Access Compliance Report

Public Rights-of-Way

(Curb Ramps)

Intersection ID: 29246	Main Street: LENSWOOD_CT	Cross Street: WOODINGTON_LN	Location: E
ADA ID: 553F01B3EB0A	Ramp Type: PerpDiag	Initial Pass/Fail: Fail	Overall Compliance: No
Severity Score: 33.75			
Codes/Mitigation Info/Possible Solution		Field Measurements/Component Compliance

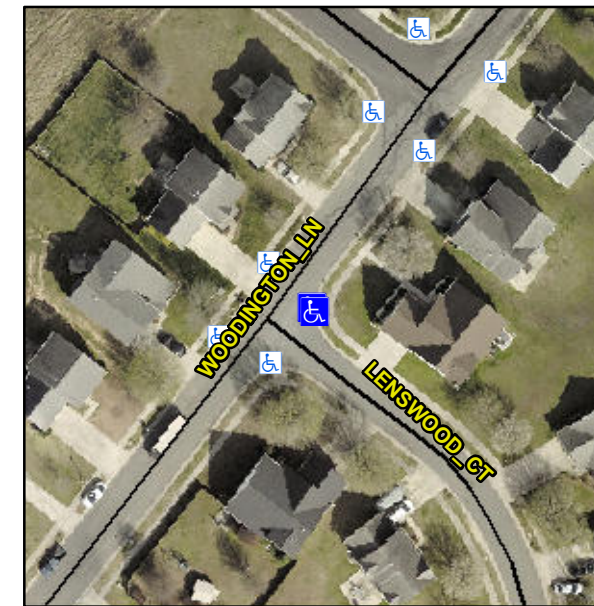
Not Found, R304.5.1, R304.2.2, R304.5.3

Compliance	Description	Data	Compliance	Description	Data
N/A	Ramp Length (in)	50.0	No	Ramp Slope (%)	10.7
No	Ramp Width (in)	47.5	No	Ramp XSlope (%)	5.6
N/A	Flare Type LT	N/A	N/A	Flare Type RT	N/A
N/A	Flare Slope LT (%)	N/A	N/A	Flare Slope RT (%)	N/A
N/A	Flare Traversable LT?	N/A	N/A	Flare Traversable RT?	N/A
N/A	Landing Length (in)	N/A	N/A	DWS Provided?	N/A
N/A	Landing Width (in)	N/A	N/A	DWS Contrast?	N/A
N/A	Landing Slope (%)	N/A	N/A	DWS Length (in)	N/A
N/A	Landing X Slope (%)	N/A	N/A	DWS Full Width?	N/A
N/A	Landing Curb? (Y/N)	N/A	N/A	DWS Offset (in)	N/A
N/A	Shared Landing?	N/A			
N/A	Gutter Ponding?	N/A	N/A	Gutter Slope (%)	N/A
N/A	Gutter Lip Ht (in)	N/A	N/A	Gutter X Slope (%)	N/A
N/A	Painted X Walk1?	No	N/A	Painted X Walk2?	No
	X Walk 1 Direction	To NW		X Walk 2 Direction	To SW
N/A	X Walk 1 Width (in)	N/A	N/A	X Walk 2 Width (in)	N/A
	X Walk 1 Slope (%)	1.2		X Walk 2 Slope (%)	3.4
	X Walk 1 X Slope (%)	2.4		X Walk 2 X Slope (%)	2.8

Remove & Replace Curb Ramp With Two New Directional Ramps or Equivalent.
